**MODIFICATION REQUEST:
GLOBAL SWITCH SYDNEY 2 DATA CENTRE
273 PYRMONT STREET, ULTIMO**

MP 08_0222 MOD 2

Director General's
Environmental Assessment Report
Section 75W of the
Environmental Planning and Assessment Act 1979

March 2012

Figure 2: Approved Cross Section

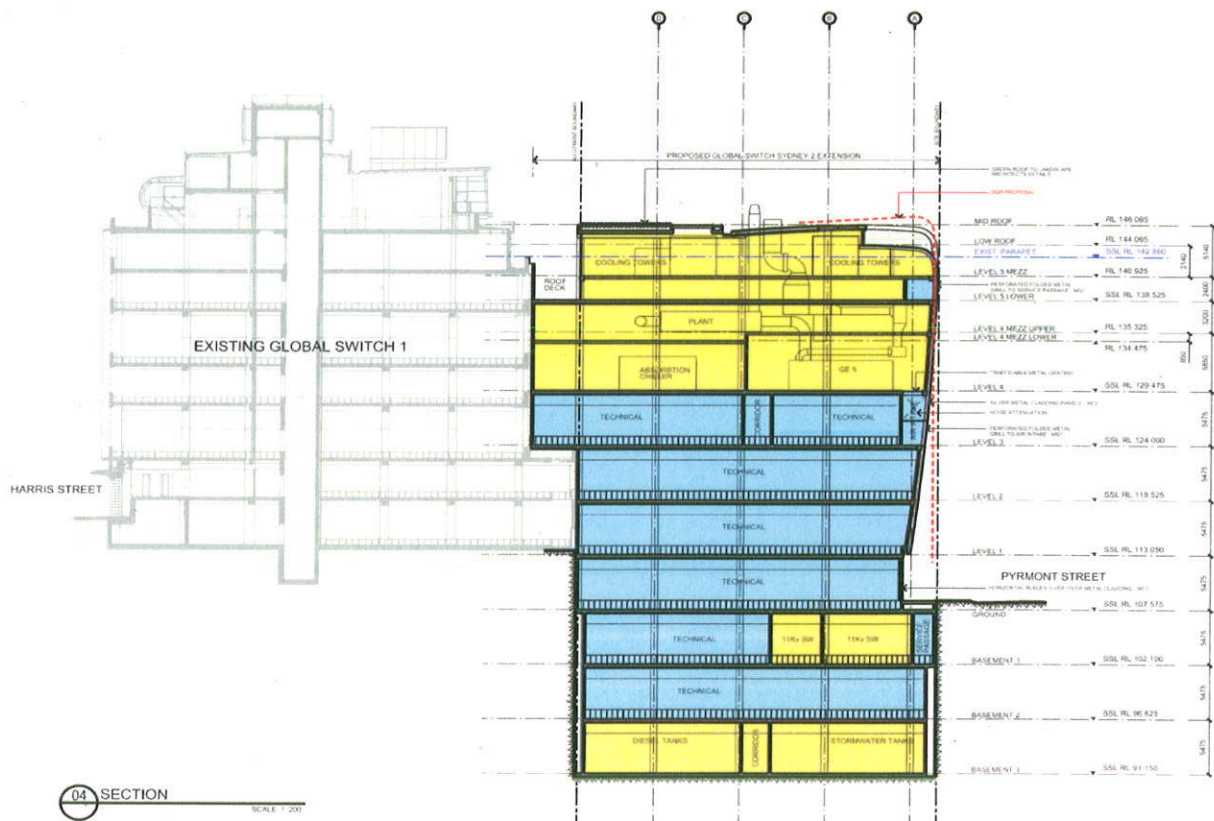
Modification 2 seeks to modify the approved Global Switch 2 Data Centre by:

- deleting the two lower basement levels and reducing the size of the remaining basement level;
- reducing the Gross Floor Area of the building from 22,285m² to 18,175m² and plant machinery area from 15,227m² to 7,615m²;
- re-configuring the floor levels and space allocation of the plant rooms;
- undertaking the development in two main building stages, including staged payment of Section 94 Contributions;
- replacing the co-generation for the first stage of the development by drawing power from the existing Global Switch 1 electrical supply;
- introducing an energy efficient free cooling air conditioning system to offset the deletion of the original proposed tri-generation system;
- removing the gas engines from the upper levels; and
- relocating the roof level breakout area to the north of the building to coincide with the new position of the lift core.

The approved plans and proposed modifications are shown in **Figure 2** and **Figure 3**.
